## Public Utility Commission

September 15, 2021

**Re: NWPP Detailed Design Doc**

Figure 1: Reproduction of Idaho Power’s Wind ELCC Results<sup>2</sup>

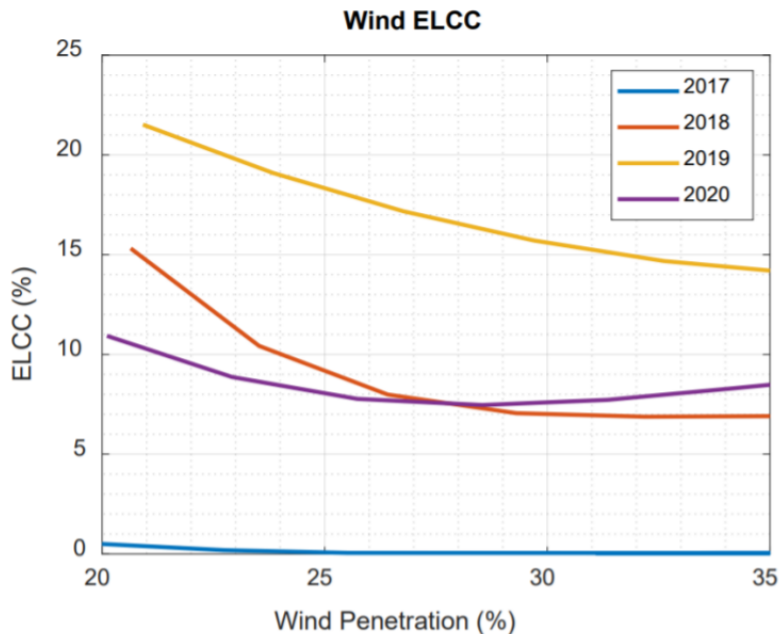
3. Staff concurs with NWPP that a probabilistic approach is an equitable method to value variable energy resources and that ELCC is a well-established method.
4. Staff worries that analyzing just three years of data will allow too much variation in the capacity value of variable energy resources. Consider for example Idaho Power’s current IRP showing that yearly variation in wind generation can vary the ELCC significantly:

In the Idaho Power example in Figure 1, the years 2017 and 2019 have significantly different wind ELCC values than the other years which illustrates the importance of having many years to average over. Conducting modelling using one year or limited observation set for renewable generation will likely overstate power reliability if the historical period is relatively stable in weather conditions. The E3 December 2020 Capacity Report states that, “Most LOLP models use at least thirty (30) years of historical weather data and eight (8) years of renewable generation profiles in order to accurately converge on statistically significant ELCC values.”<sup>3</sup> Given the great importance of the resource adequacy effort, a high level of modelling complexity including use of multiple years of generation profiles is warranted.
